Prairie Island Nuclear Generating Plant
Operated by Nuclear Management Company, LLC

Supplement to License Amendment Request (LAR) to Revise the Spent Fuel Pool Criticality Analyses and Technical Specifications (TS) 3.7.17, "Spent Fuel Pool Storage" and 4.3, "Fuel Storage" (TAC Nos. MC5811 and MC5812)

PRAIRIE ISLAND NUCLEAR GENERATING PLANT
Response to Request for Additional Information

Figure 4.3.1-1
Spent Fuel Pool Burned/Fresh Checkerboard Cell Layout

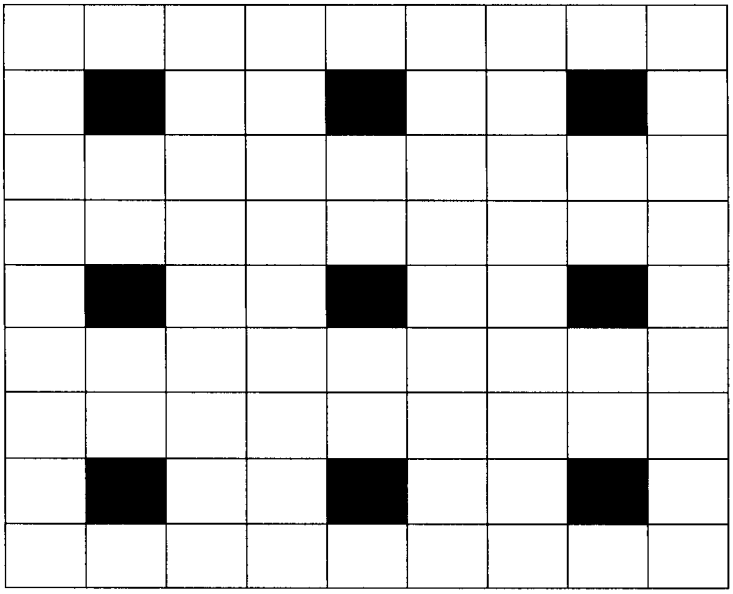
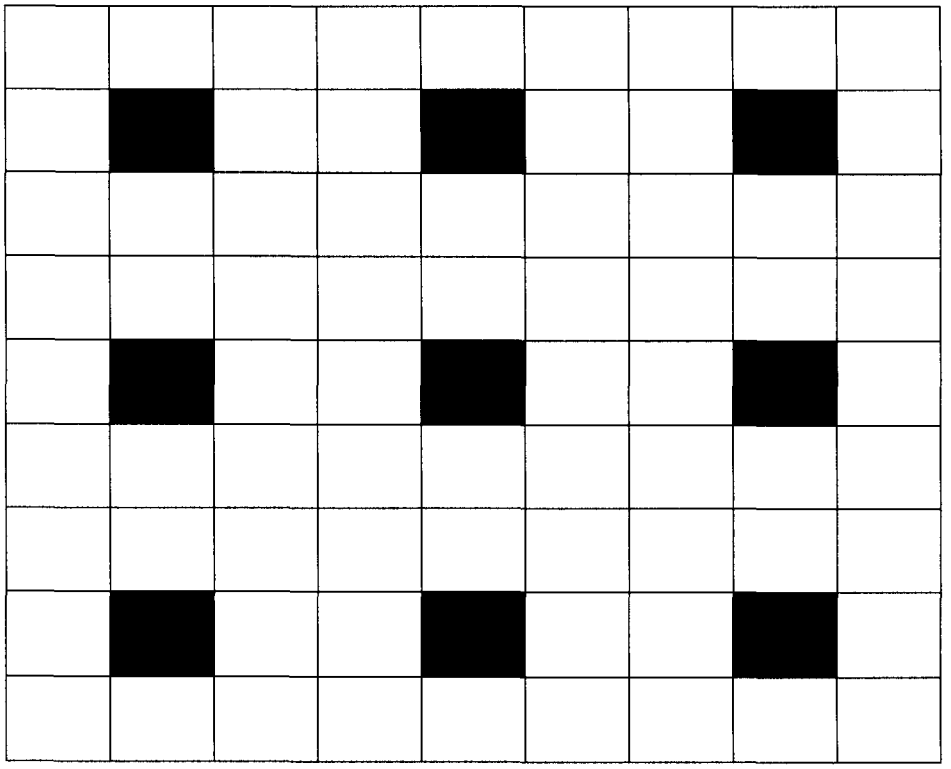
NMC's proposed TS Figure 4.3.1-1 allows the storage of fresh fuel assemblies in the spent fuel pool with or without gadolinium based on ensuring that adjacent spent fuel assemblies satisfy minimum burnup requirements. However, the licensee did not propose TS limits that will require a minimum gadolinium loading, in accordance with assumptions used in the criticality analyses, in the fresh fuel prior to placing it in the designated storage locations. Therefore, the staff requests that the licensee provide additional information demonstrating that sufficient controls will be put in place to ensure fresh fuel assemblies loaded in the spent fuel storage racks will be appropriately controlled based on the amount of gadolinium.

The legend for "Fresh Fuel" on proposed TS Figure 4.3.1-1 is revised to include minimum gadolinia (GAD) requirements. The revised figure is provided in Enclosures 2 and 3 of this supplement. With this change, the minimum required gadolinia loading in the fresh fuel is specified and will be controlled by NMC procedures which reference this Figure.

Fresh Fuel: Must be less than or equal to Nominal 4.95 w/o ^{235}U
No restrictions on burnup
Assemblies with GAD shall have a minimum of 4 fuel rods with a minimum concentration of 4.0 w/o Gd_2O_3

Burned Fuel: Must satisfy minimum burnup requirements of Figures 4.3.1-3 **or** 4.3.1-**4**, depending on **presence** of GAD rods in fresh fuel

Burned Fuel: Must satisfy minimum burnup requirements of Figures 4.3.1-3 or 4.3.1-4 depending on presence of GAD rods in fresh fuel
